Access Compliance Report

Public Rights-of-Way

Intersection ID: 20840	Main Street: SARDIS_LN	Cross Street: SARDIS_RD	Location:	E
ADA ID: A42731C260B2	Ramp Type: Perp	Initial Pass/Fail: Fail	Overall Compliance: No	Severity Score: 22.5

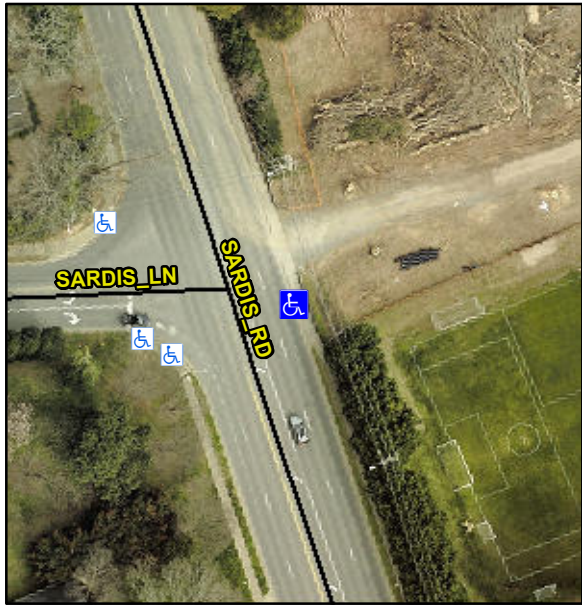
Codes/Mitigation Info/Possible Solution			Field Measurements/Component Compliance					
	Possible Solutions:		Compliance	Description	Data	Compliance	Description	Data
	Remove & Replace Entire Ramp.		N/A	Ramp Length (in)	60.0	No	Ramp Slope (%)	9.4
			No	Ramp Width (in)	45.5	No	Ramp XSlope (%)	2.4
			N/A	Flare Type LT	N/A	N/A	Flare Type RT	N/A
			N/A	Flare Slope LT (%)	N/A	N/A	Flare Slope RT (%)	N/A
			N/A	Flare Traversable LT?	N/A	N/A	Flare Traversable RT?	N/A
			N/A	Landing Length (in)	N/A	N/A	DWS Provided?	N/A
			N/A	Landing Width (in)	N/A	N/A	DWS Contrast?	N/A
			N/A	Landing Slope (%)	N/A	N/A	DWS Length (in)	N/A
			N/A	Landing X Slope (%)	N/A	N/A	DWS Full Width?	N/A
Surveyor Notes:			N/A	Landing Curb? (Y/N)	N/A	N/A	DWS Offset (in)	N/A
N/A			N/A	Shared Landing?	N/A			
PROW/ADA:			N/A	Gutter Ponding?	N/A	N/A	Gutter Slope (%)	N/A
Not Found, R304.5.1, R304.2.2, R304.5.3			N/A	Gutter Lip Ht (in)	N/A	N/A	Gutter X Slope (%)	N/A
